September 24, 2012  
NND-12-0458  
10 CFR 50.55a

Virgil C. Summer Nuclear Station (VCSNS) Units 2 and 3  
Combined License Nos. NPF-93 and NPF-94  
Docket Nos. 52-027 & 52-028

Subject: Alternative Request  
Reactor Vessel Flow Skirt ASME Code Jurisdictional Boundary

Reactor Vessel Flow Skirt ASME Jurisdictional Boundary

**Figure 2**

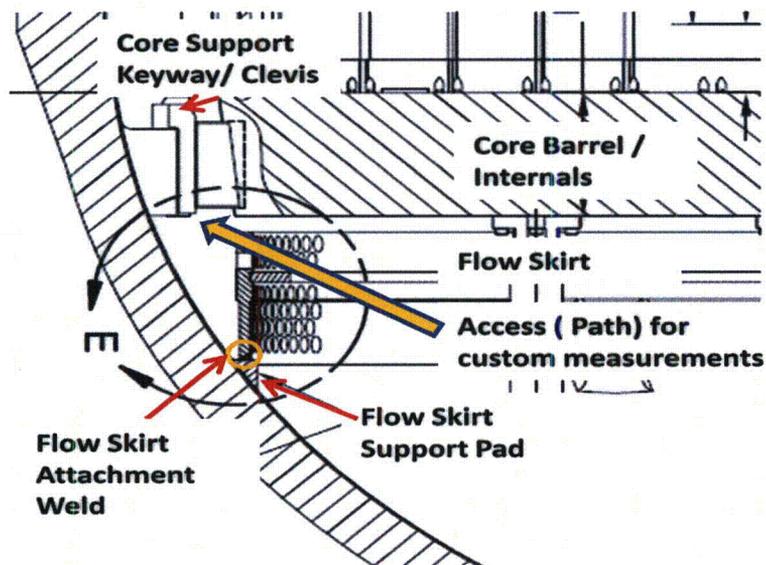
The need for a customized fit-up of the reactor vessel internals (RVI) in the field as part of field assembly prevents the flow skirt attachment weld from being completed at the RV fabricator's shop. On-site installation of the RVI necessitates custom fitting and machining of the clevis inserts for proper interface between the core support clevis and radial support keyways. The position of an installed RVFS would prohibit effective measurement and final machining of the core support clevis and clevis inserts. (See Figure 2 for details).

As shown in Figure 2, there is no clear line of sight between the inner diameter of the RVFS and the RV core support keyways and clevises. Furthermore, the distance between the top of the RVFS and the bottom of the RV internals lower core support plate is no more than two inches and therefore does not provide sufficient access to the core support keyways and clevises.

Figure 3

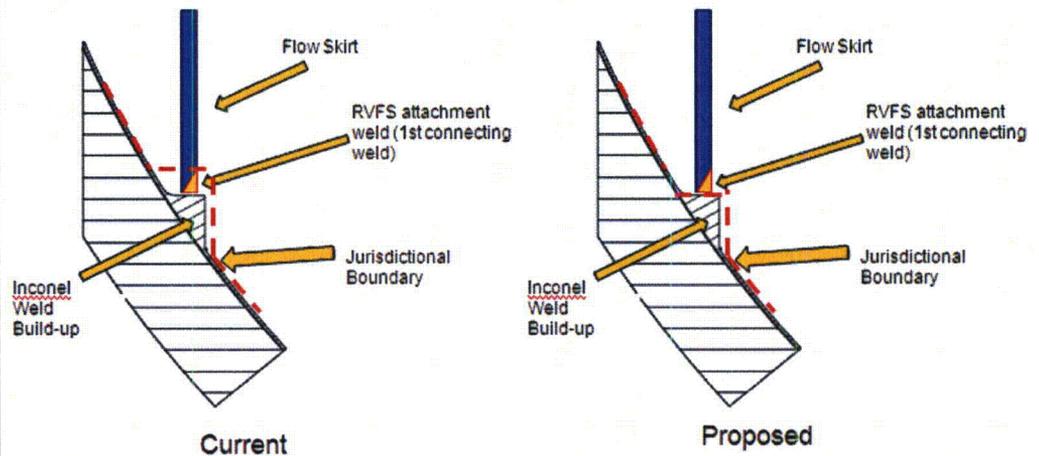
**Proposed Alternative:** It is proposed that the RVFS attachment weld be excluded from the RV jurisdictional boundary. The attachment weld will be performed in the field in accordance with ASME Code requirements and will be identified in a Code N-5 data report. Figure 3 below illustrates the current jurisdictional boundary versus the proposed jurisdictional boundary.

**Basis for Use:** The attachment welds will be performed in the field in accordance with ASME Code requirements and be identical to that which would be performed in the RV fabricator's shop. The attachment welds shall be identified in a Code N-5 data report.

**Figure 4**

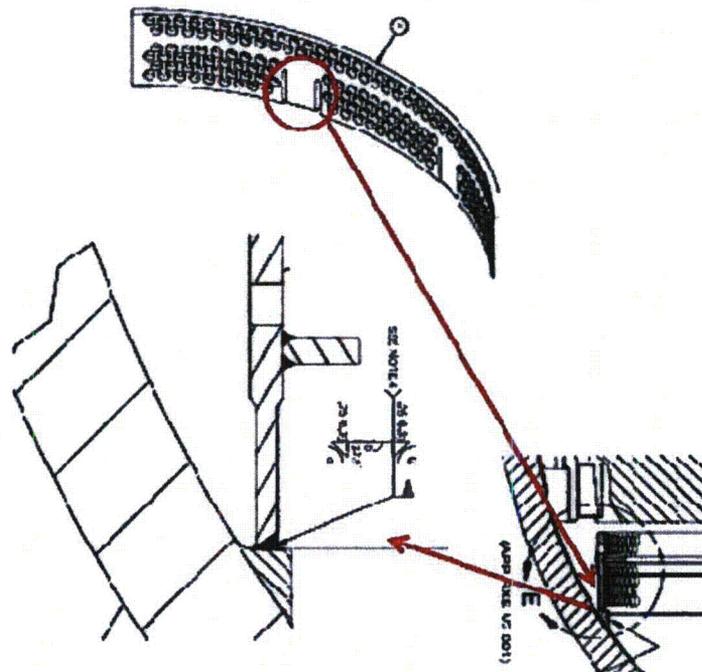
The weld configuration given in Figure 4 shows that a full penetration weld is completed between the RVFS and eight RVFS support pads included on the bottom head dome of the RV. This full penetration weld is performed from the inner diameter of the RVFS.

1. Installation welding completed by NA Certificate holder in accordance with ASME Section III paragraph NB-4430;
2. Nondestructive Examination (NDE) completed in accordance with ASME Section III paragraph NB-5262;

<p>3. NDE acceptance criteria in accordance with ASME Section III paragraph NB-5350;</p> <p>4. Quality records data package will be identified in an N-5 Code data report;</p> <p>5. Activities monitored by 3rd party inspector; and</p> <p>6. Requirements for Pre-service Inspection (PSI) and In-service Inspection (ISI) are not changed and will be in accordance with ASME Section XI IWB-2200 and IWB-2500, respectively.</p> <p>This request does not impact any plant-specific DCD Tier 1 information nor any ITAAC. This request seeks authorization to exclude the RVFS attachment welds from the RV jurisdictional boundary.</p> <p>The welds would be completed in the field to the same standards as they would if performed in the RV fabricator's shop. The attachment welds in the field would be made in accordance with ASME Code requirements for a weld governed by Subsection NB. This will assure the same level of quality and safety as if the welds were within the RV ASME Code jurisdictional boundary.</p> <p>Because there is a hardship, and this proposal is equal in both quality and safety, authorization is requested to exclude the RVFS attachment weld from the RV jurisdictional boundary in accordance with 10 CFR 50.55a(a)(3)(ii).</p>
